EPA Climate Change Documents

NSW Minerals Council Summary – November 2025

Proposed Climate Change Licensee Requirements

NSW Minerals Council Submission – November 2025

Figure 4 NSW Net Zero Model 2023-24 coal mining Scope 1 emissions forecasts compared to actual emissions (Mt CO₂-e)¹⁷

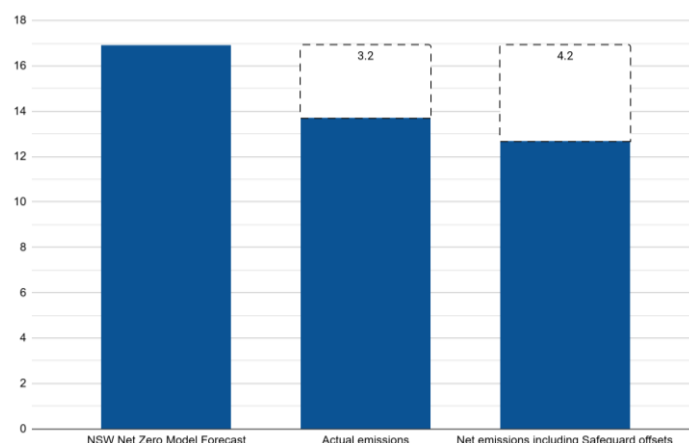
The NSW Net Zero Model includes historical data up to 2022-23 and forecasts emissions from 2023-24 onwards. However, the Commonwealth Government has already released *actual* emissions data for 2023-24, allowing a comparison between the NSW Net Zero Model's forecast emissions, and actual emissions.

This overestimate raises questions as to whether EPA policy is being guided by inflated emissions forecasts for the coal sector.
